**TEMPORARY CHANGE NOTICE REQUEST FORM**

TCN NO. 99-0481

1. PROCEDURE NUMBER EIP-ZZ-03010 REVISION NO. 006

PROCEDURE TITLE Hazardous Chemical/Oil Spill Response/Spill Cleanup Implementing Procedure

# HAZMAT SHEET

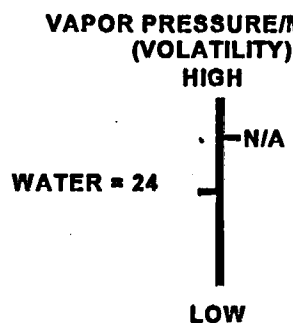
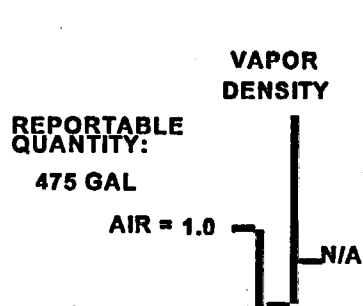
2.2 CHANGE SUMMARY Page 8i added to provide guidance for response to significant spills of anion and cation resin/SOS 99-1397

SPILL HANDLING	
DO	DO NOT
Sweep and or wet-dry vacuum spilled material	Dispose of resin in sanitary trash. Contact Chemistry to coordinate disposal of resin.
Wear Chemron suit and chemical goggles	Flush to Storm Water Runoff conveyance
Contact Duty Chemistry Supv. before cleanup of greater than 1 cu. ft.	Flush to Sanitary sewer system
